WTC DRAWING  
BOOK 19  
AB-1-K-1055

SKILLING, HELLE, CHRISTIANSEN, ROBERTSON

PROJECT	THE WORLD TRADE CENTER	TITLE	DRAWING BOOK 19 - REVISIONS AFTER FABRICATION	DATE	5/18/73
---------	------------------------	-------	---	------	---------

1. The details given in Book 19 define revisions to be made to previously fabricated steel members, or to members under fabrication.
2. The location of such revisions and the detail number are shown in Structural Steel Plans, using the following symbol:

Reference Des 6-ABZ-41

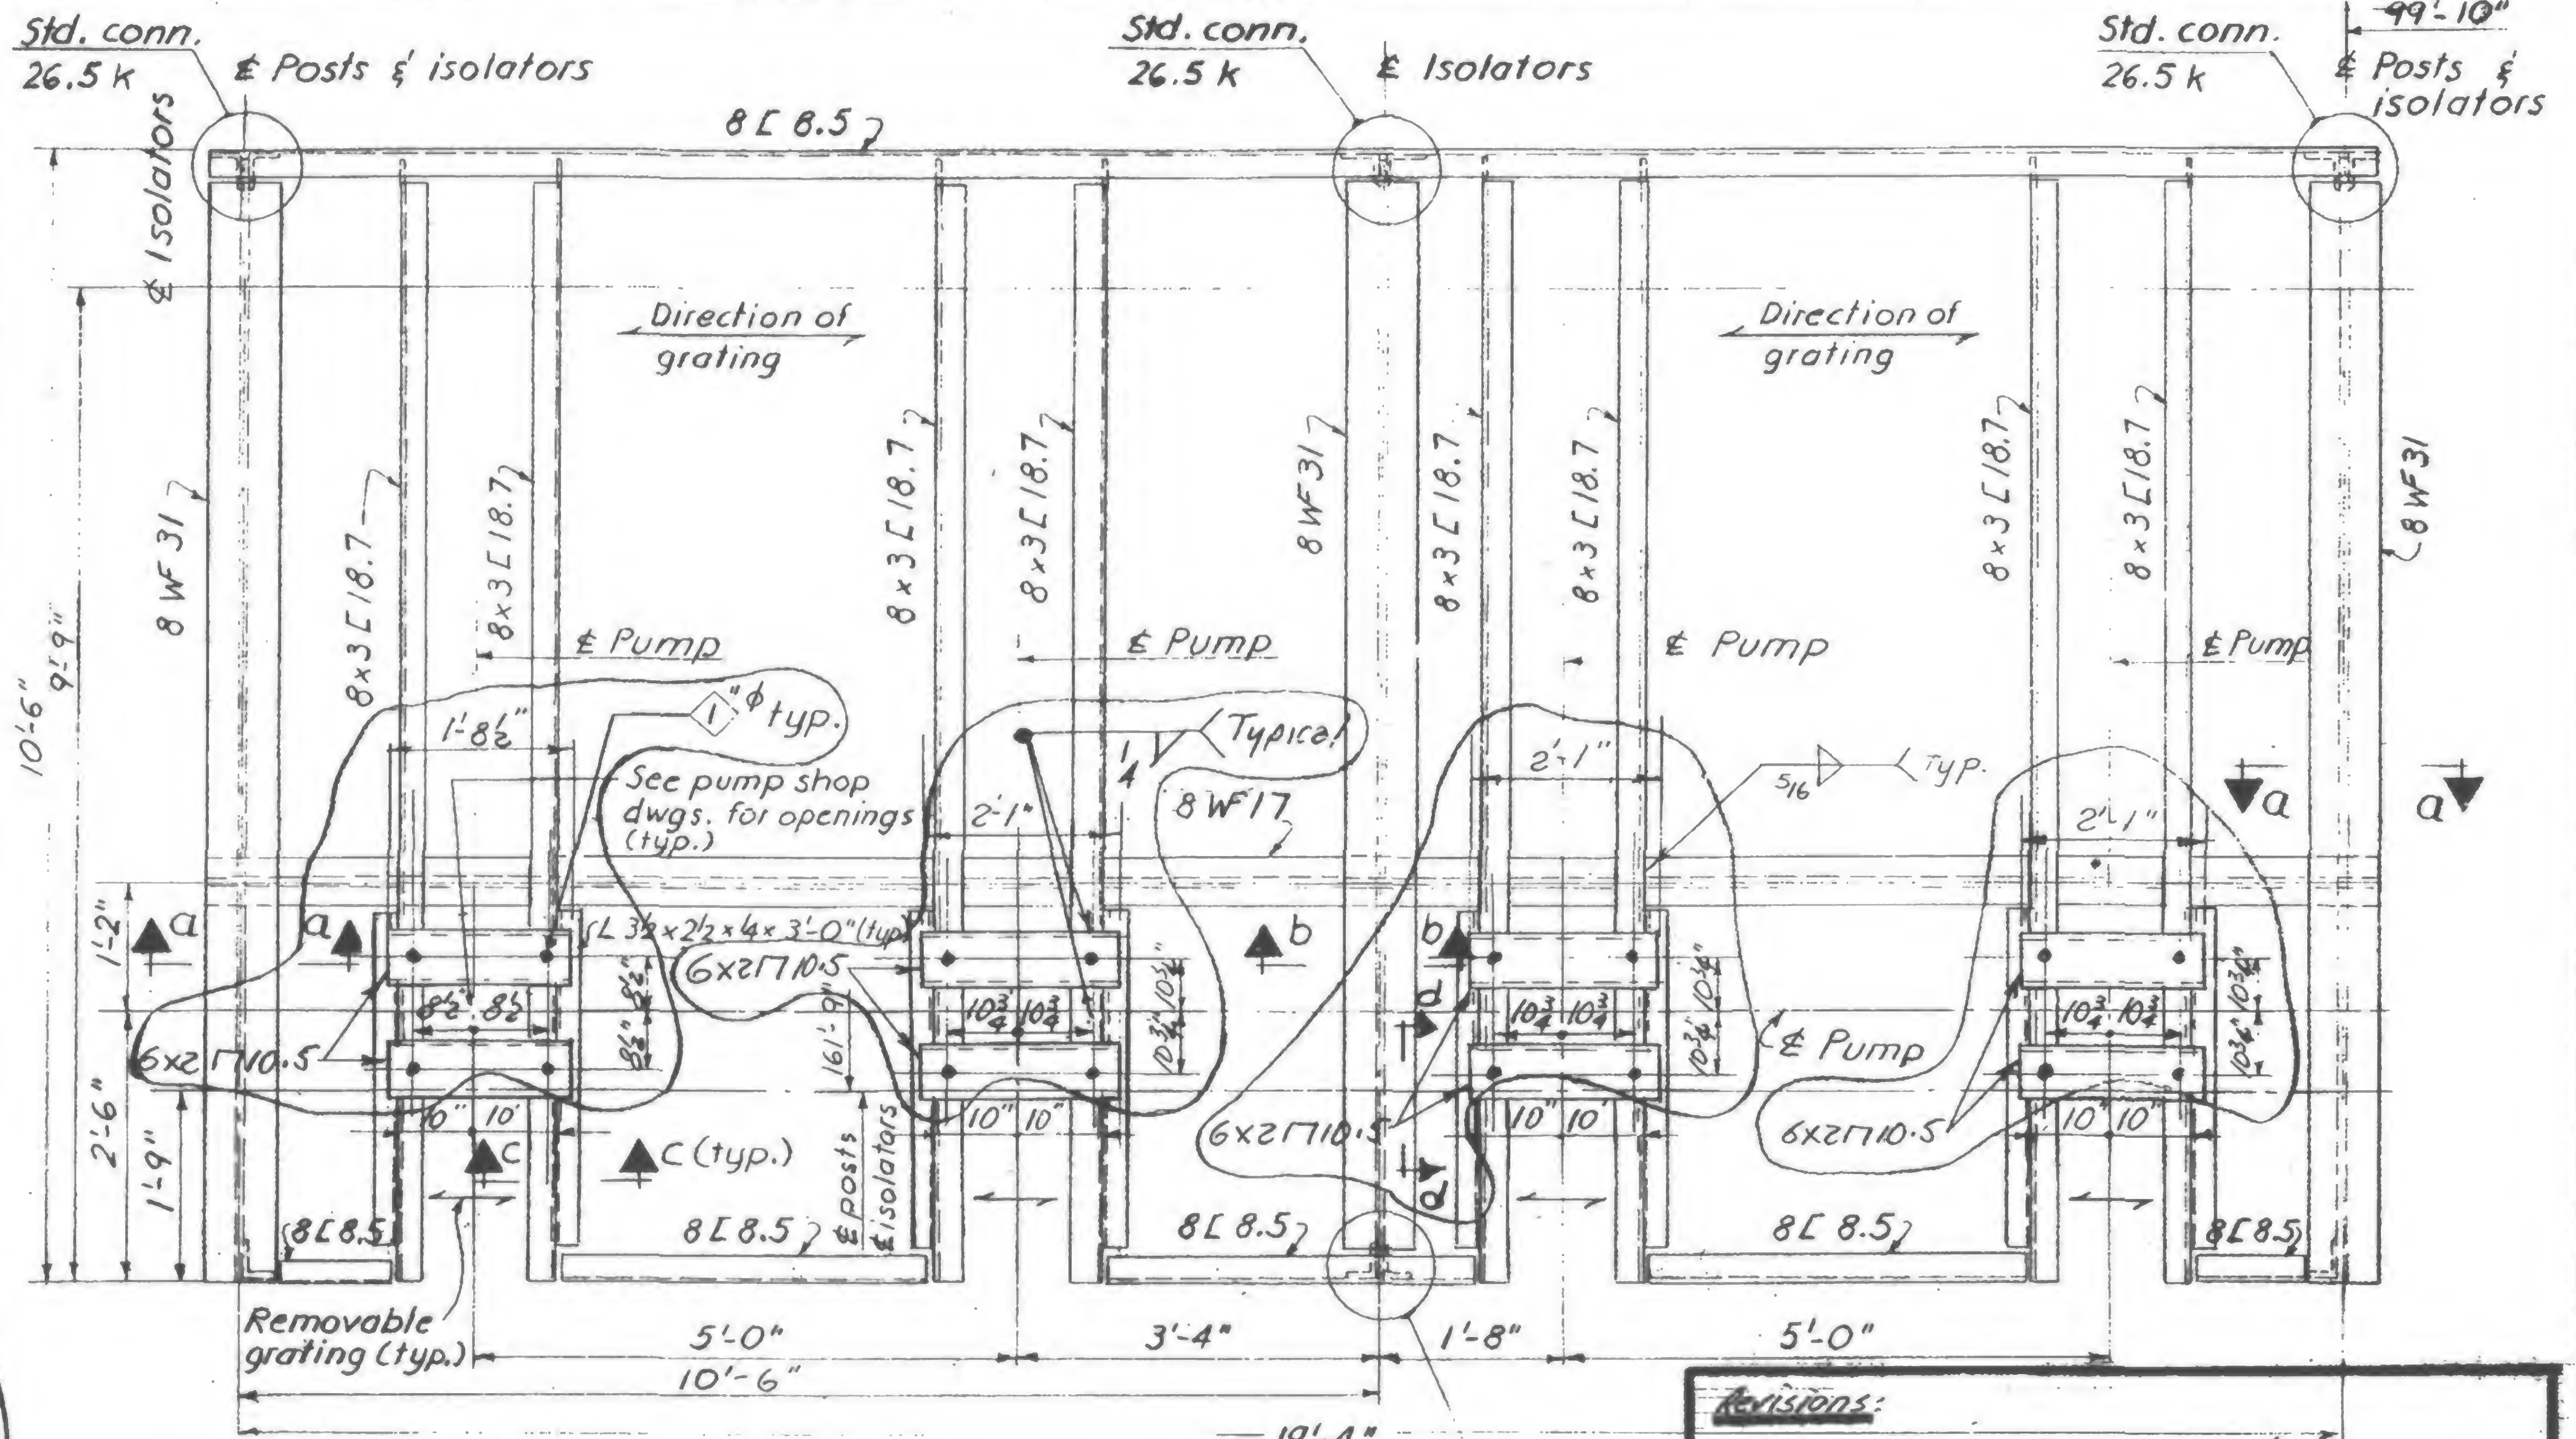
Add 6x277's @ pump base locations. Revisions included herein are circled

DRAWN  
SC  
REVIEWED

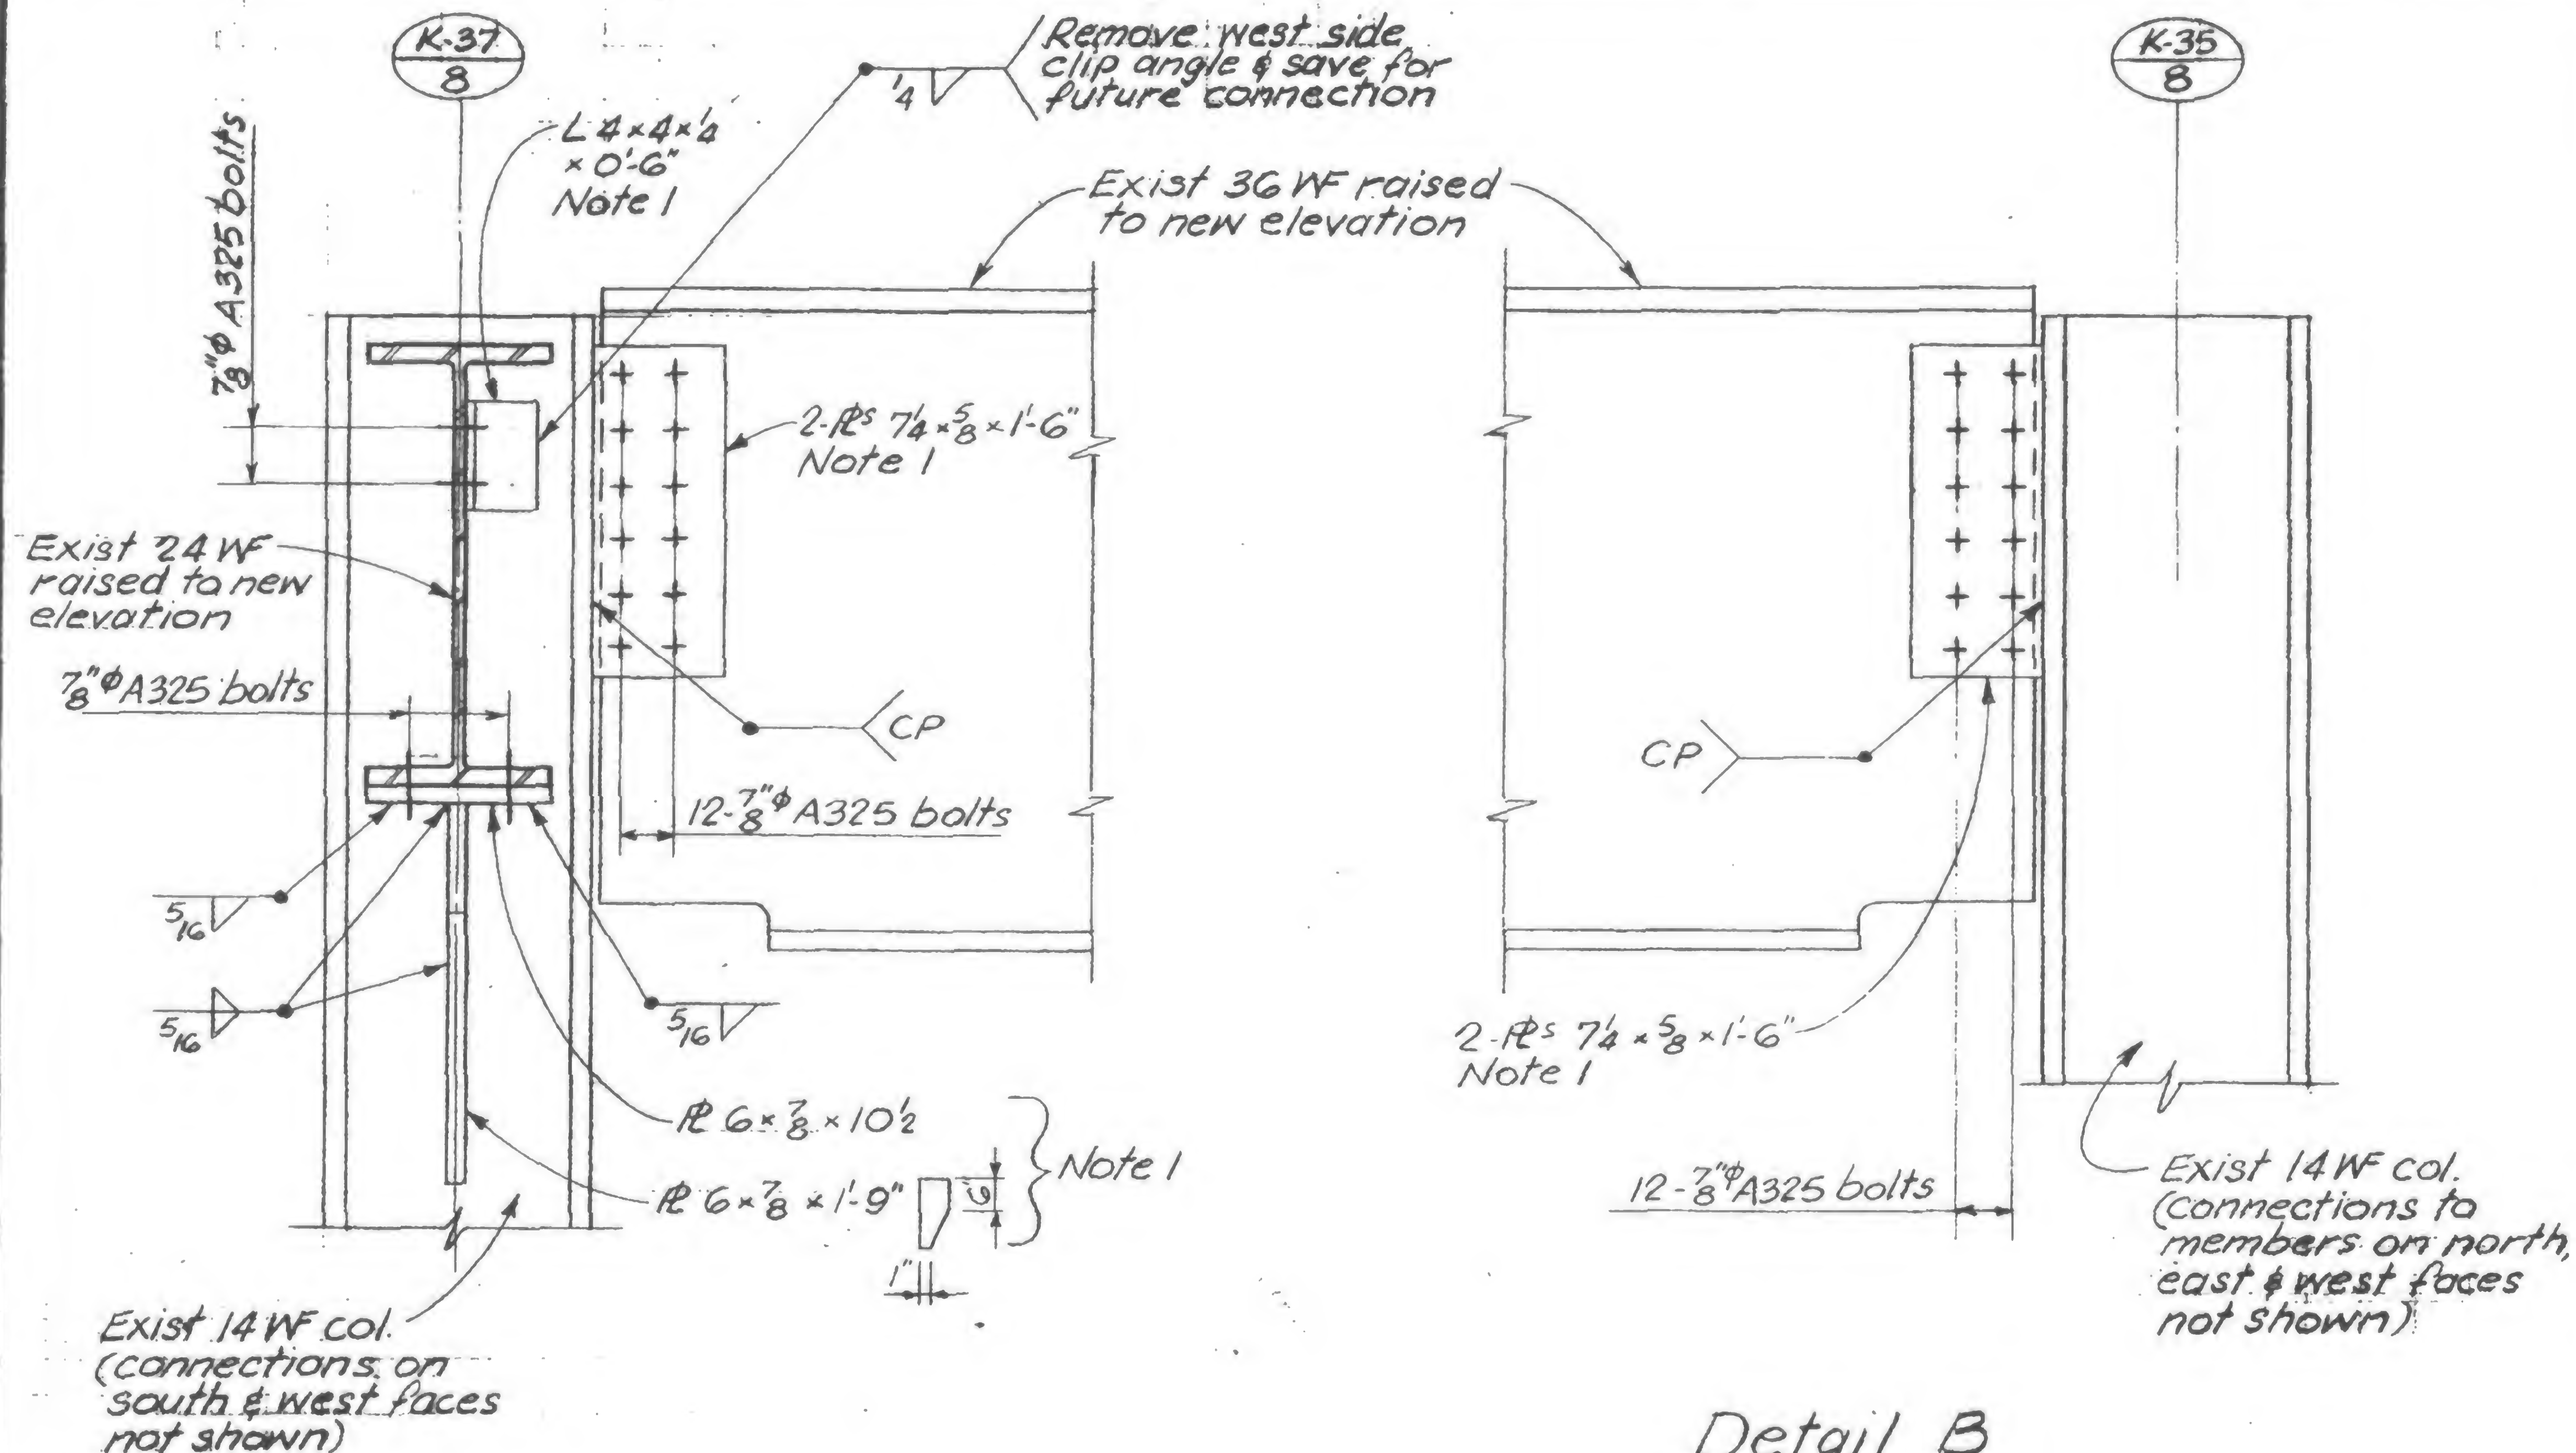
Note 1: Remove existing connection and reuse material in new location if in satisfactory condition. Bolts must be new material.

DETAIL FOR SHEAR HEAD REPAIR K31/5

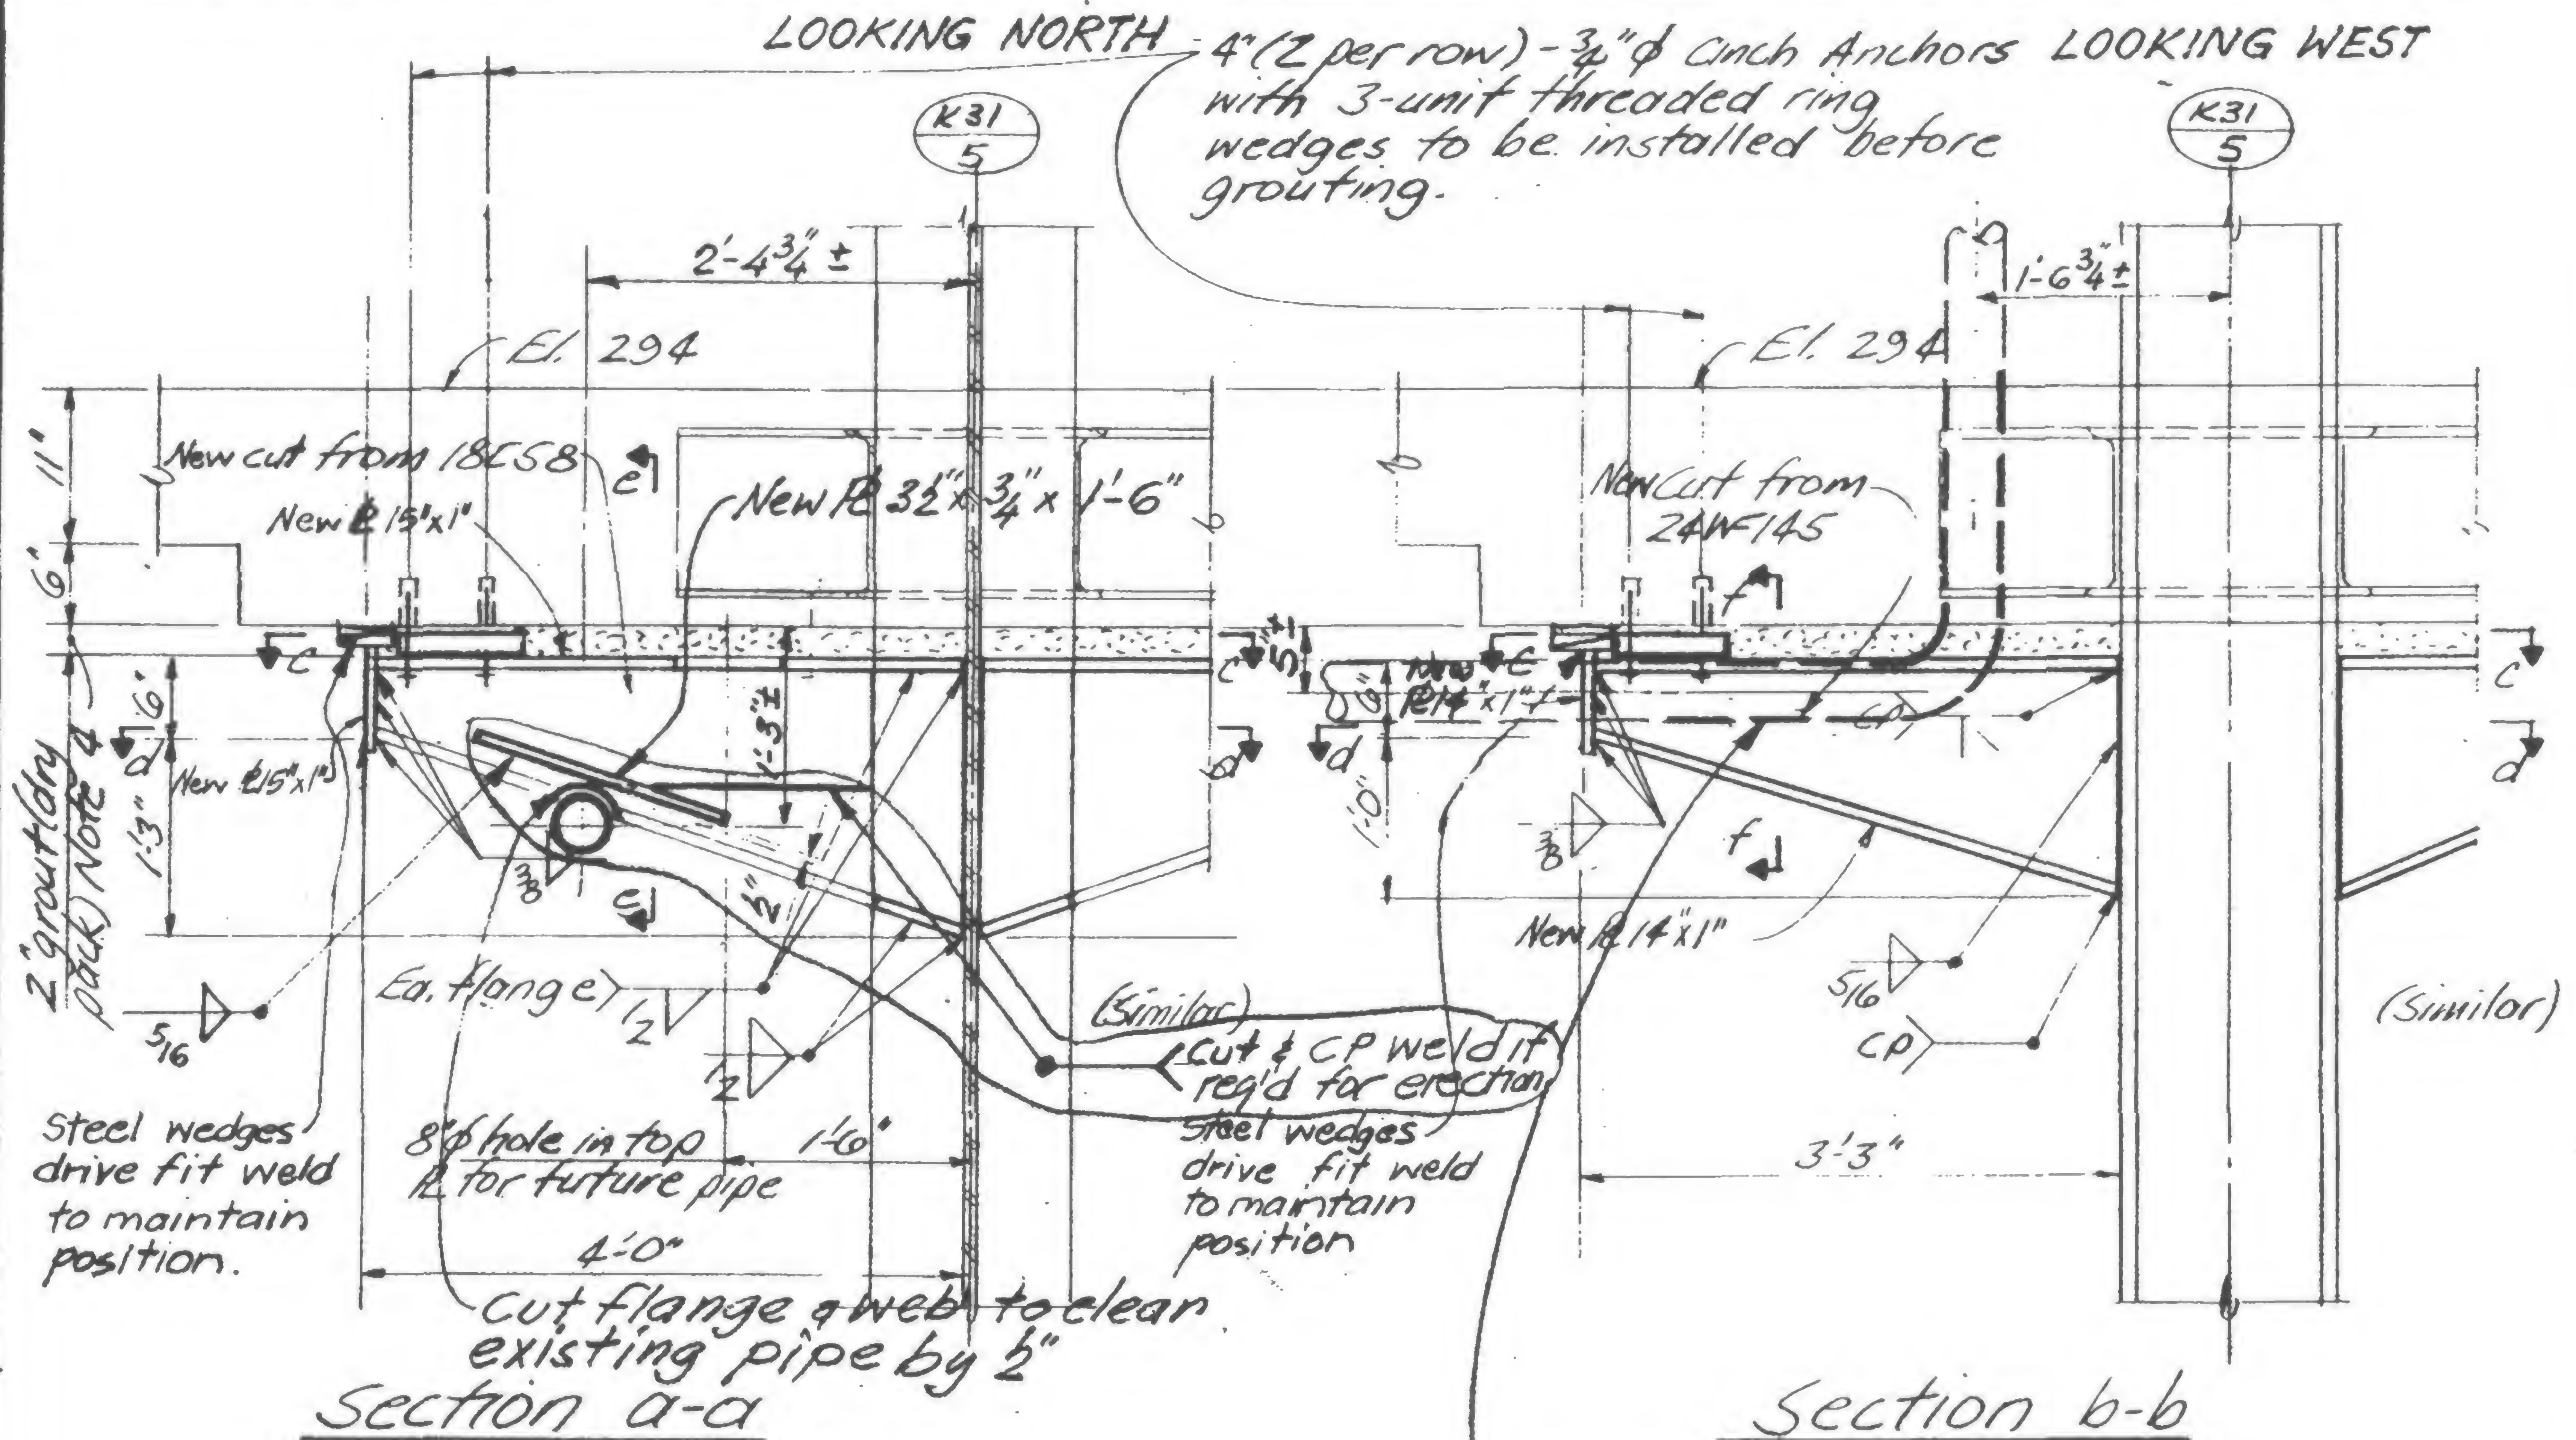
Remove existing pipe to clear new shear head. Pipe located in different position will be shown in future Central Service Drawings
